City of South Daytona Bid Addendum

Bid Number:	23-014
Bid Title:	Harborside Pump Station
Bid Opening Date:	2:00 P.M. on Thursday, July 13, 2023
Bid Addendum Number:	1
Bid Addendum Date:	June 27, 2023

PUMPSTATION CONTROL PANELS
INCLUDE VFD & GENERATOR RECEPTABLE
NOT TO SCALE

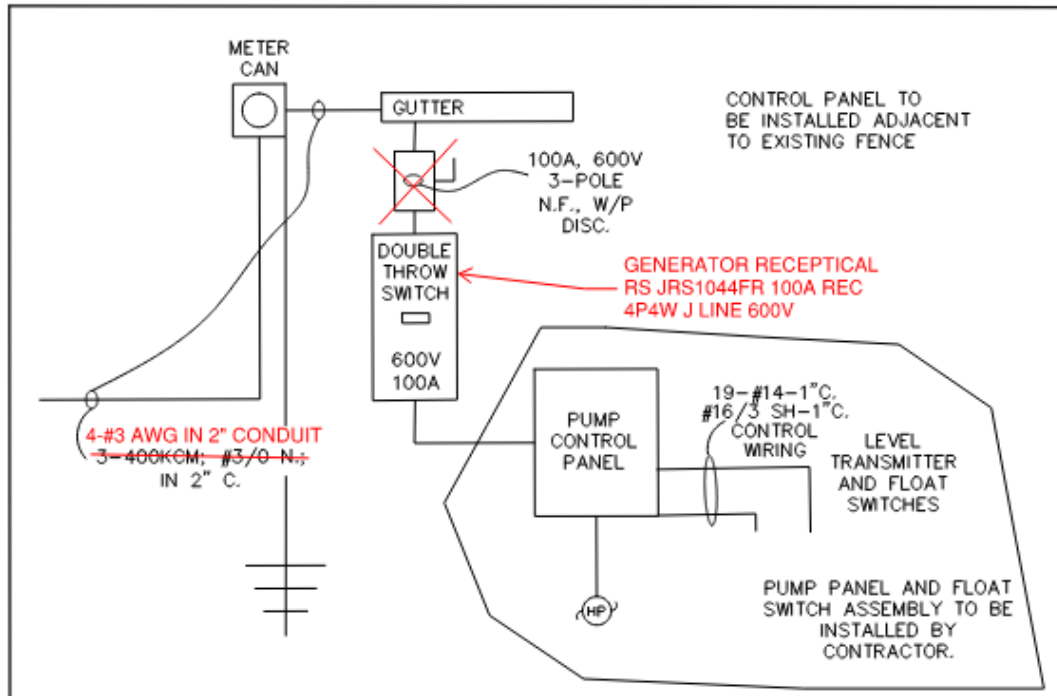
- See the below picture for clarification on the control panel.

2. PROVIDE FPL-APPROVED IN-LINE METER CAN IN LOCATION SHOWN IN PLANS SUITABLE FOR 100-AMP, 3-PHASE SERVICE AT ~~460 VOLTS~~ 230 V
3. PROVIDE 100 AMP, 3-POLE, 600 VOLT, ADJUSTABLE TRIP THERMAL-MAGNETIC CIRCUIT BREAKER WITH SHUNT TRIP IN NEMA 1 ENCLOSURE. LABEL THIS BREAKER AS "SERVICE MAIN DISCONNECT."

4. SERVICE GROUND TO BE ~~#1/0 BARE COPPER WIRE~~ ~~SERVICE MAIN BREAKER ENCLOSURE~~ TO BUILDING FOOTER REINFORCING STEEL BAR, TO TWO EACH, 20-FOOT DRIVEN COPPER ELECTRODES, 20 FEET ON CENTERS, MINIMUM, AND IF PRESENT, TO METAL WATER PIPE.

- Remove Reference to VFD in Plans
- The Reference to 460 Volt is changed to 240 Volt
